**Re: GE-Pittsfield/Housatonic River Site
Unkamet Brook Area (GECD170)
Fourth Supplement to the Pre-Design Investigation Report for Unkamet Brook Area
Removal Action**

Accordingly, GE has prepared this *Fourth Supplement to the Pre-Design Investigation Report for Unkamet Brook Area Removal Action* (Fourth Supplement) in response to the above-referenced conditional approval letter.

FIGURE
1

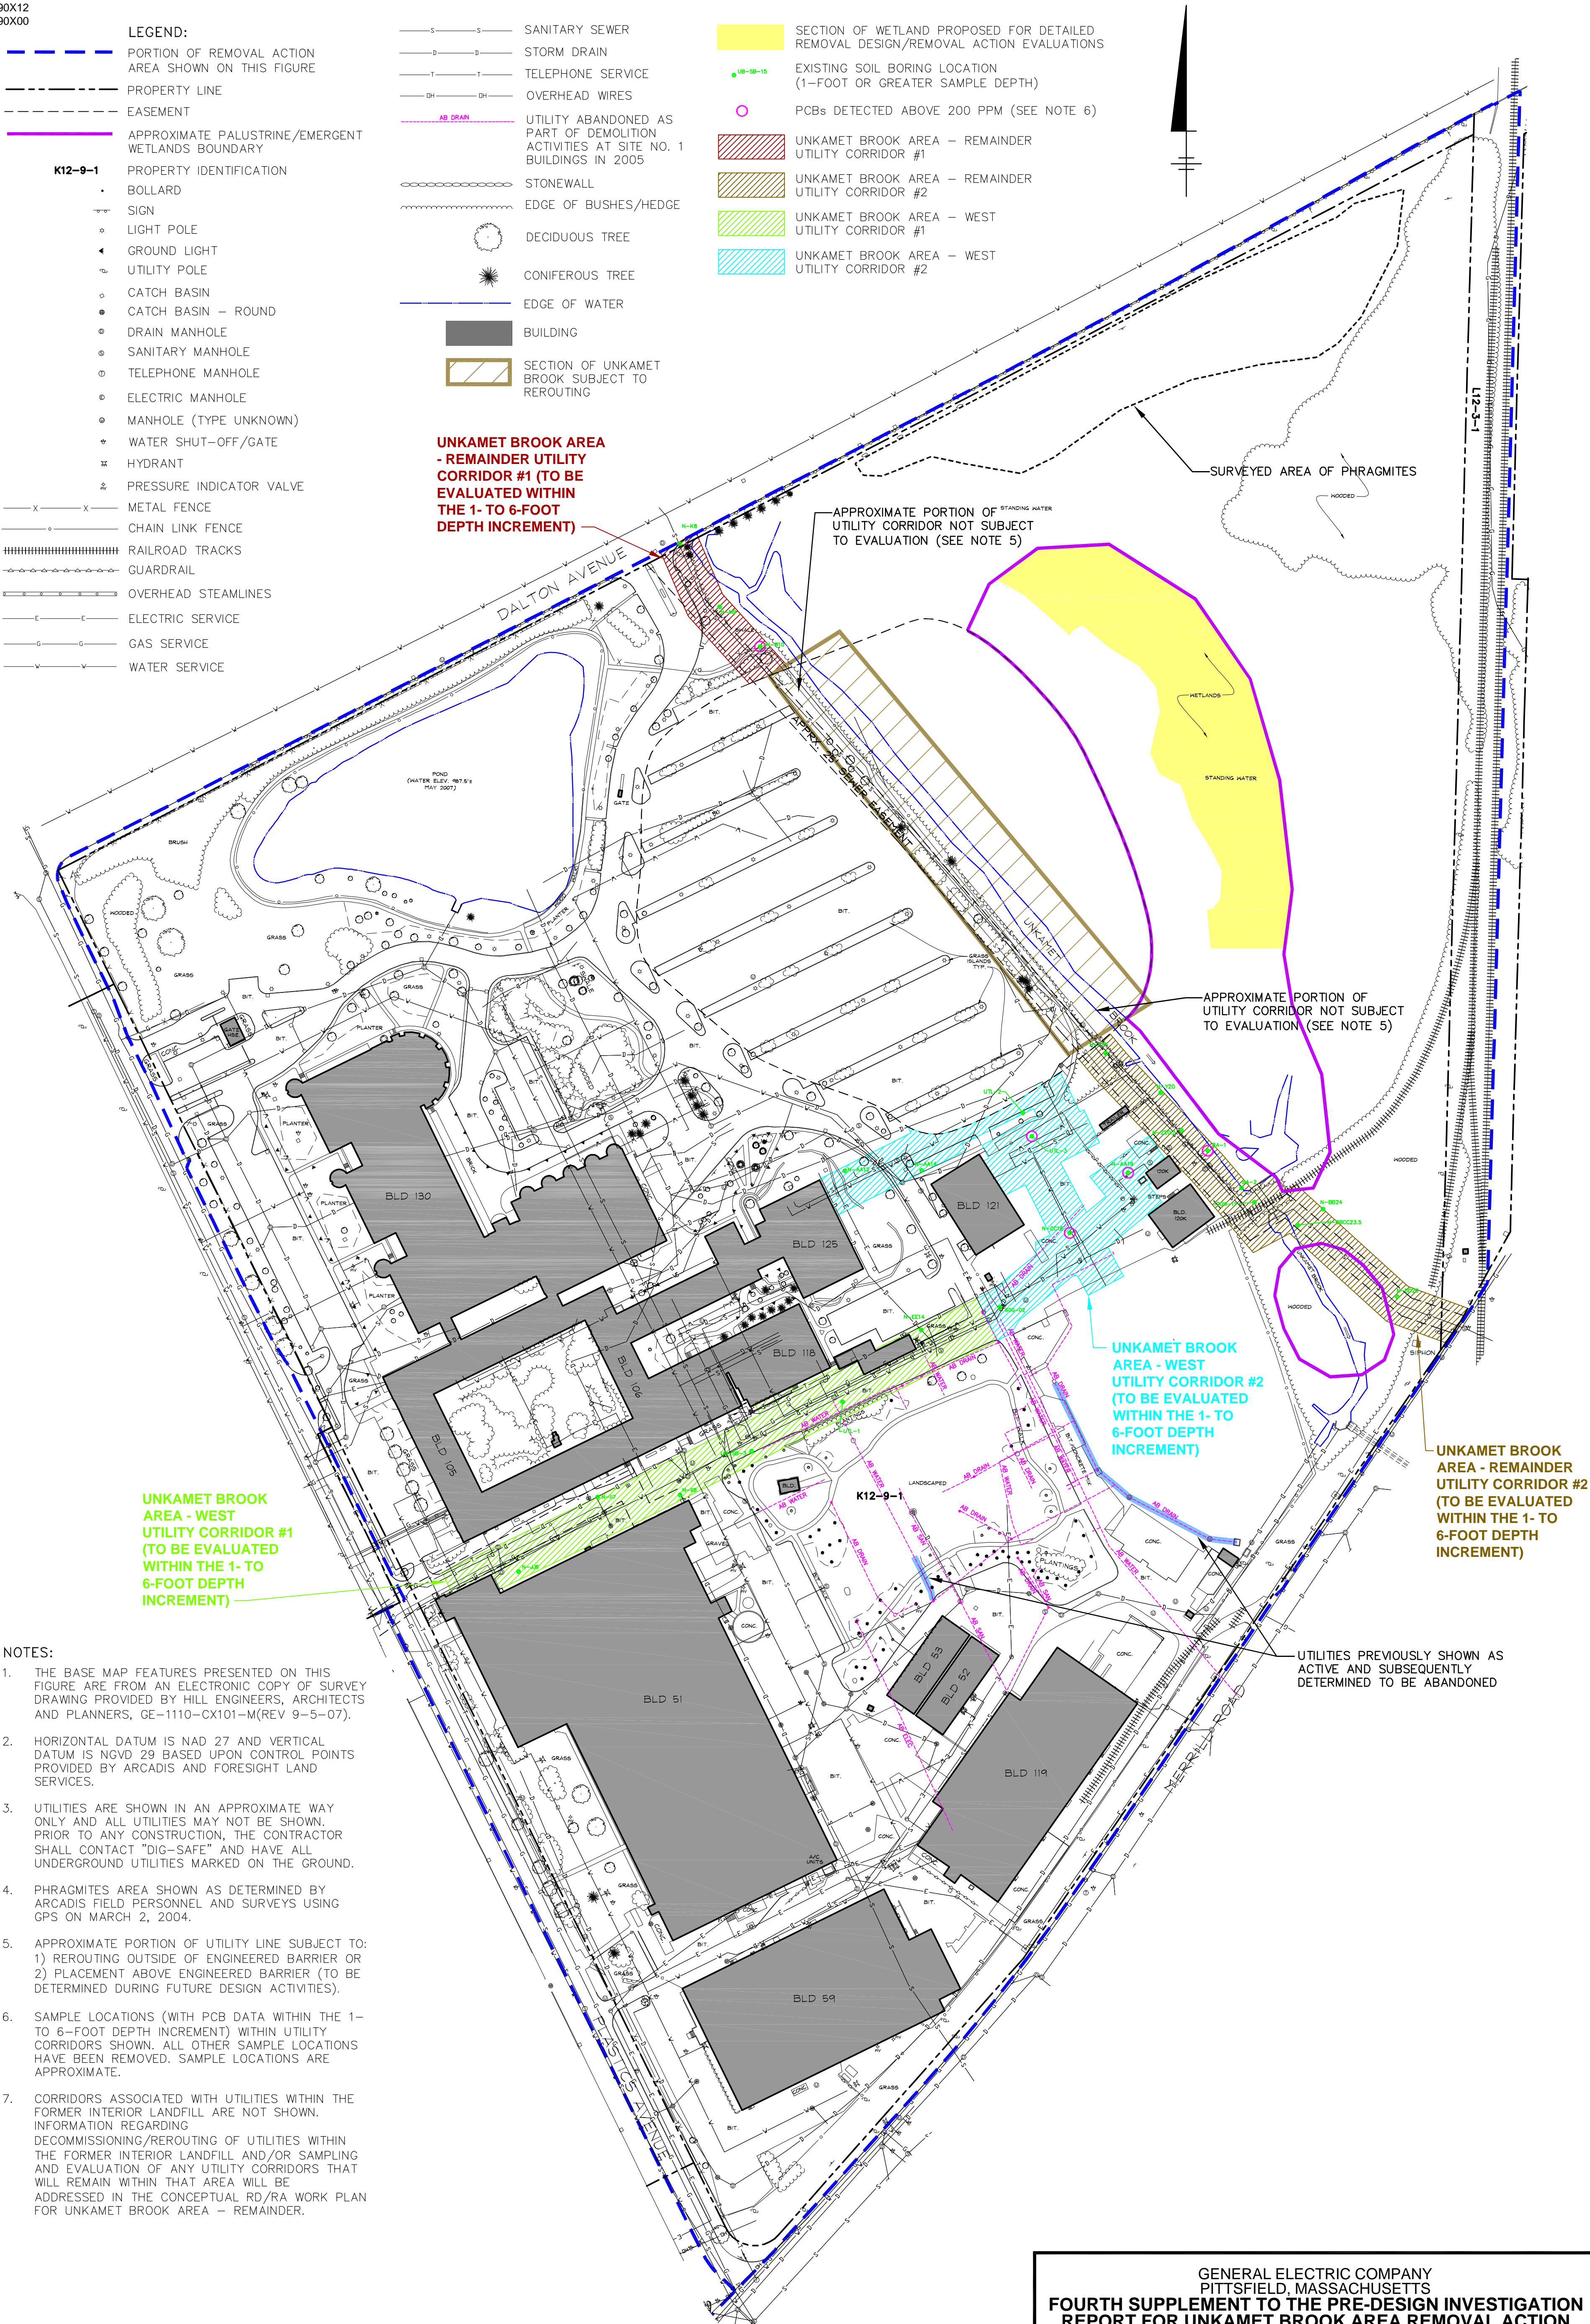
As indicated in the November 4, 2008 conditional approval letter, GE has agreed to evaluate the soils within the sanitary sewer utility corridor in the former North Area located along Unkamet Brook and running approximately north to southeast, as two separate utility corridors in the Conceptual RD/RA Work Plan for Unkamet Brook Area-Remainder. The first corridor (labeled "Unkamet Brook Area-Remainder Utility Corridor #1" on attached Figure 1) will encompass the soils within the corridor located north of the former interior landfill and the second corridor (labeled "Unkamet Brook Area-Remainder Utility Corridor #2" on Figure 1) will encompass the soils within the corridor located to the south of the former interior landfill.

Additionally, GE has agreed to evaluate the soils within the utility corridors in the former North Area running west to east along Buildings 51, 105, 106 and 118, and in the vicinity of Buildings 125, 121 and 120k, as two separate corridors as part of the Conceptual RD/RA Work Plan for Unkamet Brook Area-West. The first corridor (labeled "Unkamet Brook Area-West Utility Corridor #1" on Figure 1) will encompass the soils within the utility corridor associated with the utilities servicing Buildings 105, 106, and 118, and running from the western edge of the corridor along Building 51 to the point slightly west of sample location 60G-02. The second corridor (labeled "Unkamet Brook Area - West Utility Corridor #2" on Figure 1) will encompass the soils within the remaining portion of the corridor associated with the utilities servicing Buildings 125, 121, and 120K.

In accordance with the *Statement of Work for Removal Actions Outside the River (SOW)*, and as noted on Figure 1, these utility corridors will be evaluated within the 1- to 6-foot depth increment.

**SUMMARY OF UTILITY CORRIDORS SUBJECT
 TO EVALUATION WITHIN UNKAMET BROOK
 AREA - FORMER EAST AREA**

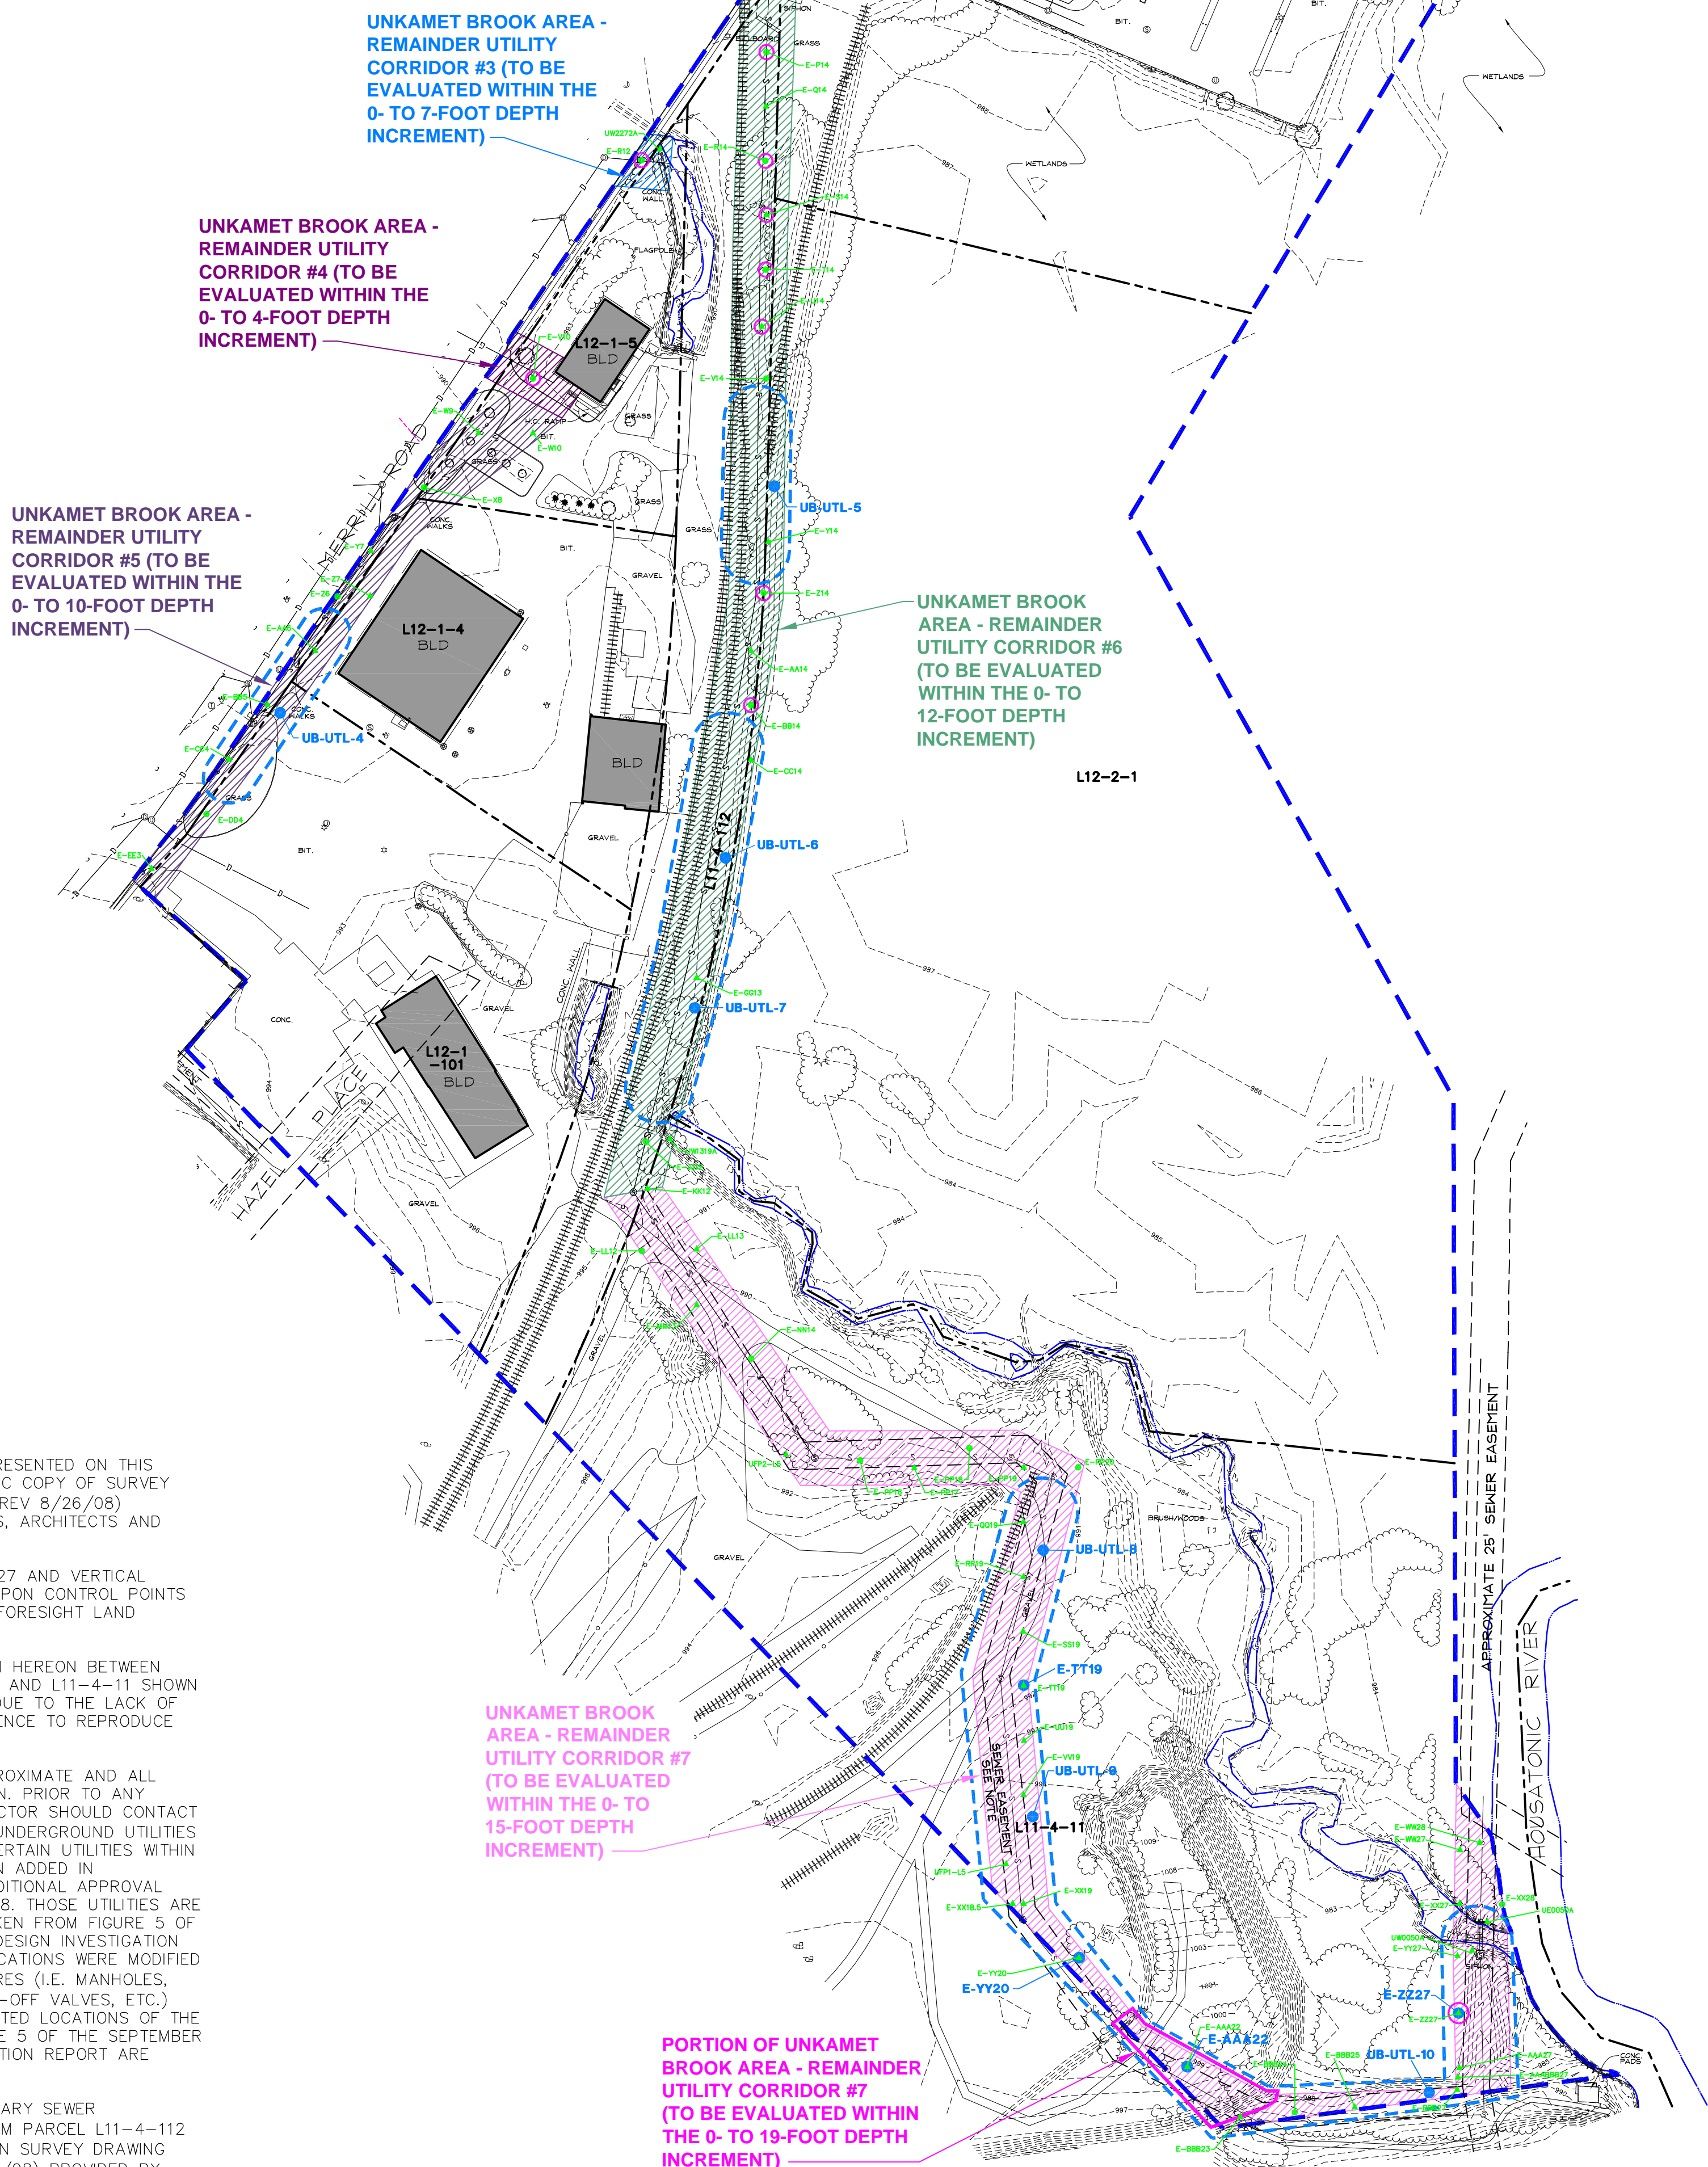
In the Conceptual RD/RA Work Plan for Unkamet Brook Area-Remainder, GE will evaluate the soils within the storm drain utility corridor that enters the northernmost portion of Parcel L12-1-5 from Merrill Road (labeled "Unkamet Brook Area-Remainder Utility Corridor #3" on attached Figure 2). In accordance with the SOW, the evaluation for utilities within non-GE-owned properties will include soils present in the utility corridor that may need to be removed during an emergency repair. Using City of Pittsfield utility drawings, GE determined the maximum depth of utility bedding to be approximately 7 feet. Therefore, this utility will be evaluated within the 0- to 7-foot depth increment.

Additionally, in the Conceptual RD/RA Work Plan for Unkamet Brook Area-Remainder, GE will evaluate the soils within the utility corridor of the gas line servicing the building on Parcel L12-1-5 (labeled "Unkamet Brook Area-Remainder Utility Corridor #4" on Figure 2) as a separate utility corridor using PCB results from sample location RAA10-E-V10. In accordance with the procedures outlined in the SOW, this utility will be evaluated within the 0- to 4-foot depth increment. It should be noted, based on conversations with Berkshire Gas Company (Berkshire Gas), that this line has been inactive since 2007 and is currently disconnected from the main service line. Berkshire Gas did indicate, however, that this line may be reactivated/reinstalled in the future. As a conservative measure, GE has elected to evaluate this line as indicated above. GE will also separately evaluate the soils within the sanitary sewer utility corridor running from west to east and abutting the gas line utility corridor. This utility corridor (labeled as "Unkamet Brook Area-Remainder Utility Corridor #5" on Figure 2) will be evaluated within the 0- to 10-foot depth increment. The evaluation will include three PCB samples (i.e., 1- to 3-foot, 3- to 6-foot, and 6- to 10-foot depth increments) from the proposed sample location UB-UTL-4, along with the PCB results from any remaining samples within the utility corridor, including sample location RAA10-E-V10.

GE will also evaluate the soils within the sanitary sewer utility corridor that generally runs from Merrill Road along Unkamet Brook as two separate utility corridors. The first corridor (labeled "Unkamet Brook Area-Remainder Utility Corridor #6" on Figure 2) will encompass the soils within the utility corridor for the portion of the sanitary sewer line primarily located within Parcel L11-4-112 and will be evaluated within the 0- to 12-foot depth increment. The second corridor (labeled "Unkamet Brook Area-Remainder Utility Corridor #7" on Figure 2) will encompass the soils within the utility corridor for the portion of the sanitary sewer line primarily located within Parcel L11-4-11 and will be evaluated within the 0- to 15-foot depth increment. As noted on

Figure 2, the evaluation for the soils within the second corridor (“Unkamet Brook Area–Remainder Utility Corridor #7”) may be adjusted if the future sampling results expand the boundaries of the Removal Action Area (RAA) to beyond the southern boundary (as depicted on Figure 2).

In addition, as discussed in the Scope and Status Update, GE has determined that it will extend the proposed soil boring RAA10-E-AAA22 (Figure 2) to a depth of 19 feet below ground surface (bgs) to account for a localized mound of fill that was placed following the development of City of Pittsfield utility drawings related to the sanitary sewer line located in the southernmost portion of Unkamet Brook Area-Remainder. For the utility corridor evaluations associated with this portion of “Unkamet Brook Area–Remainder Utility Corridor #7” sewer line, polygons associated with soil boring RAA10-E-AAA22 will extend to a depth of 19 feet bgs within the area labeled “Portion of Unkamet Brook Area-Remainder Utility Corridor #7 (to be evaluated within the 0- to 19-foot depth increment)” on Figure 2.
